Applicant: Brian Ivers; MnDOT
Consultant: Adam Pawelk; HTPO, Inc.
Project: MnDOT Truck Station Addition and Improvements Eden Prairie
Location: 7333 Bryant Lake Drive, Eden Prairie
Applicable Rule(s): 4, 5, 6 and 7
Reviewer(s): Azeemuddin Ahmed and Louise Heffernan; Barr Engineering Co.

The Minnesota Department of Transportation (MnDOT) is proposing a building addition, parking lot improvements, utility improvements, landscaping, and construction of stormwater management facilities at MnDOT's Eden Prairie Truck Station located at 7333 Bryant Lake Drive in Eden Prairie.

Figure 1. The site.

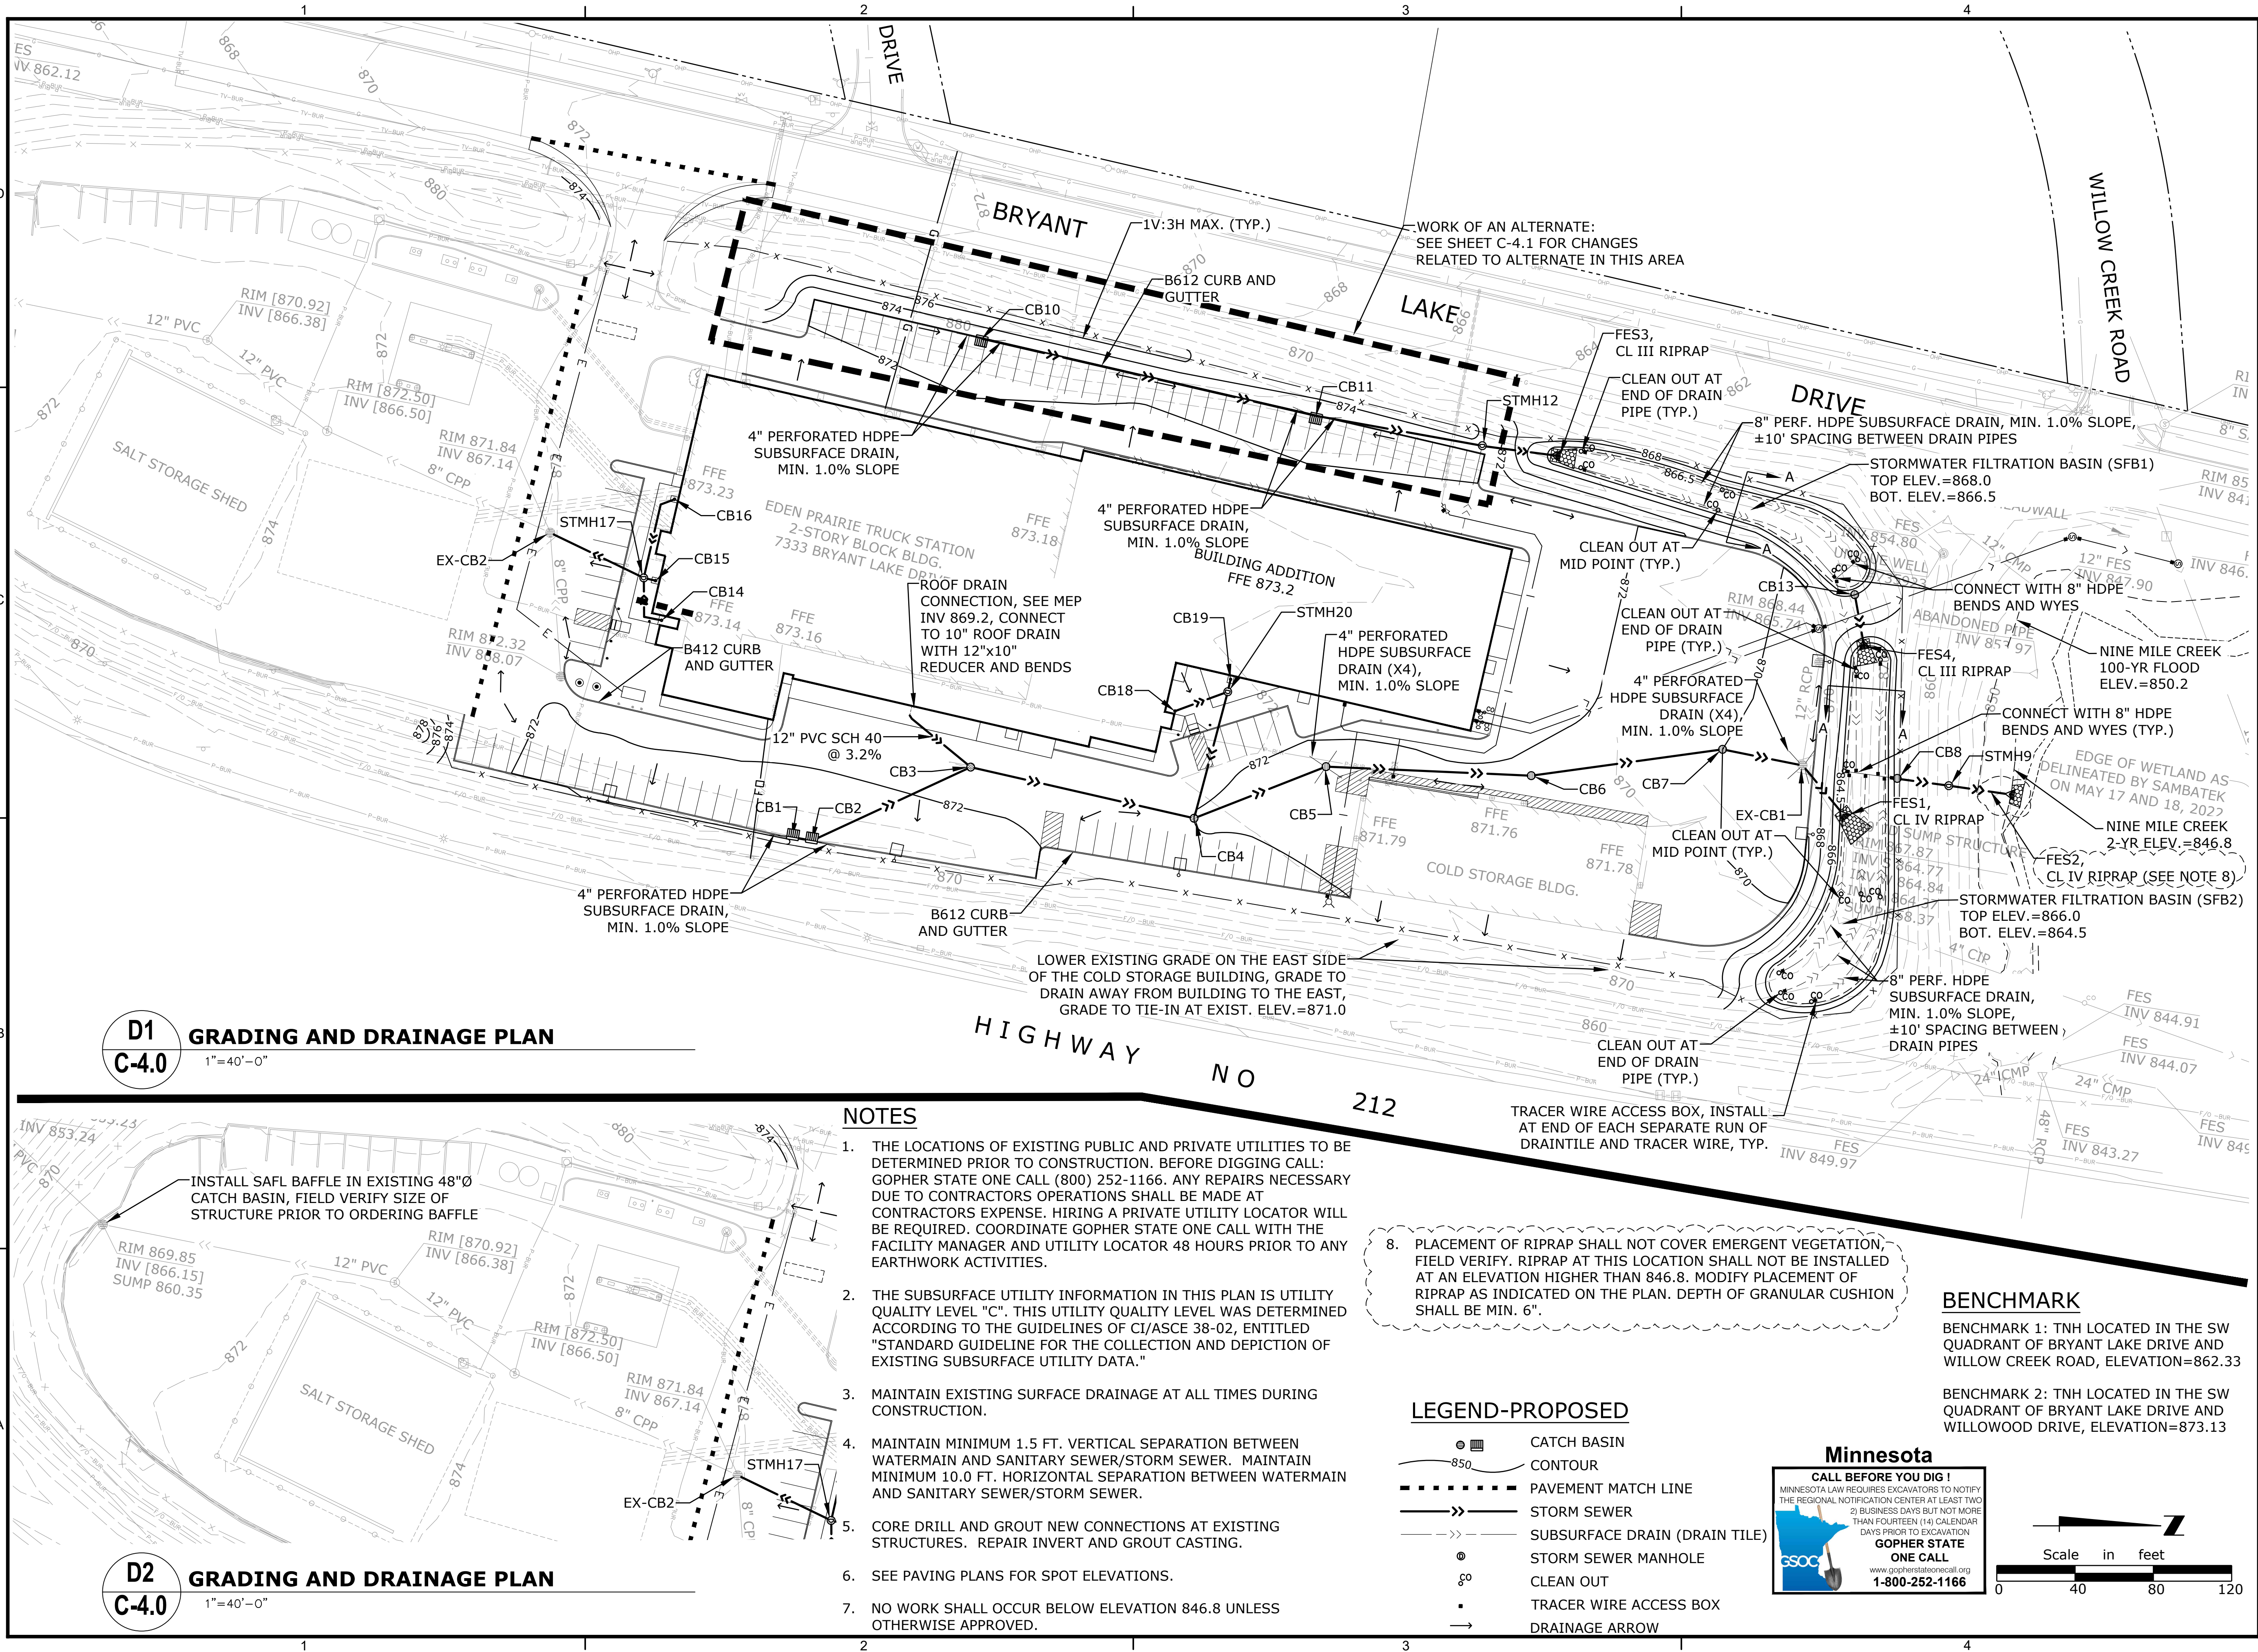
The project is a linear project, as defined by the NMCWD rules, because the proposed land-disturbing activities include construction and reconstruction of public improvements, and reconstruction of utilities in a linear corridor. The project limits – i.e., the site, for purposes of the NMCWD rules analysis – are between Highway 212 and Bryant Lake Drive, as shown in Figure 1 below.
